Product Change Notification / GBNG-20LJOX814

CCB 4253 Final Notice: Qualification of MMT as an additional final test site for selected Atmel AT27xxx device family available in 44L PLCC (16.6x16.6x4.4mm) package.

PCN #:GBNG-20LJOX814
CCB 4253_Pre and Post Change Summary

MPHL

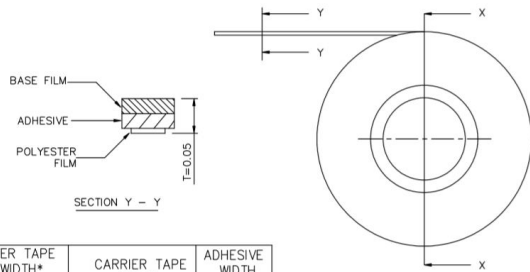
Carrier Width	Width "W" (mm)	Thickness (mm)	Sealing Mythology
32mm	25.5 +/-0.1	0.050 ±0.010	Pressure Seal

MMT

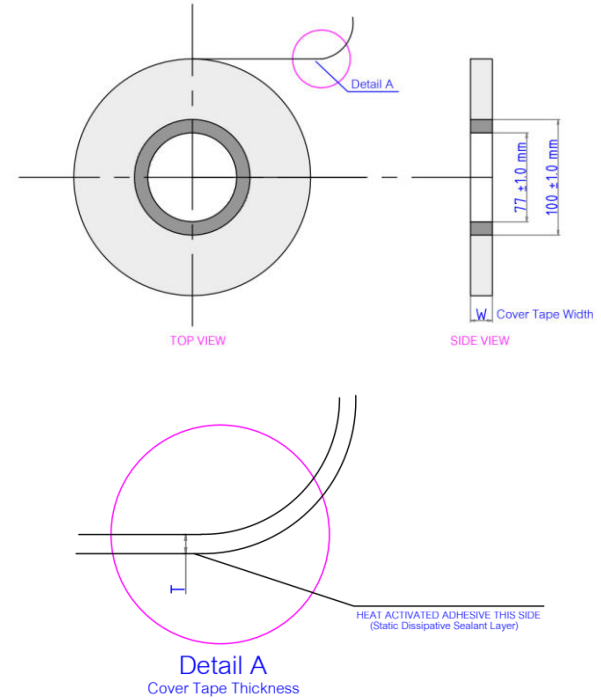
Carrier Width	Width "W" (mm)	Thickness (mm)	Sealing Mythology
32mm	25.5 +/-0.1	0.050 ±0.010	Heat Sealing

MPHL

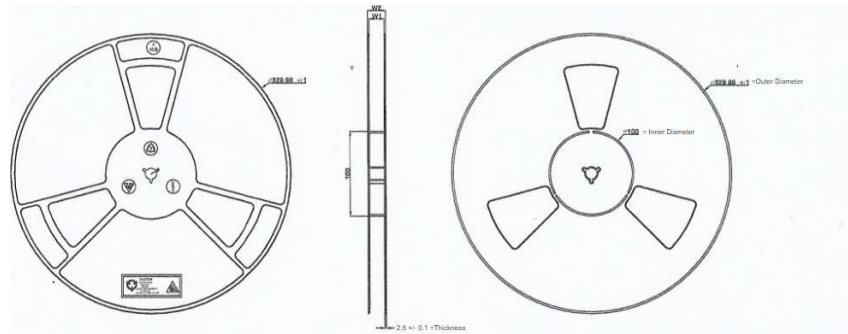
Width	Hub	Color
32mm	4inch (100mm)	White

MMT

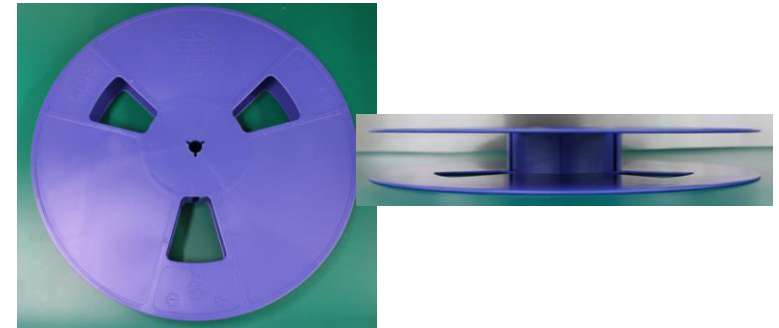
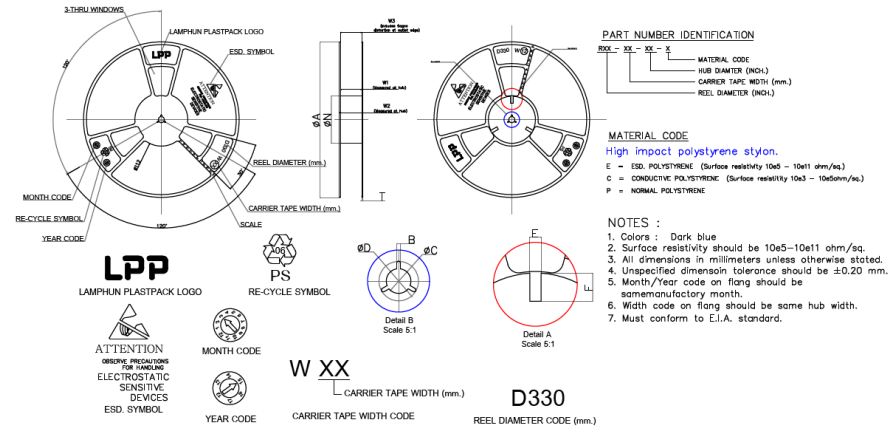
Width	Hub	Color
32mm	4inch (100mm)	Dark Blue
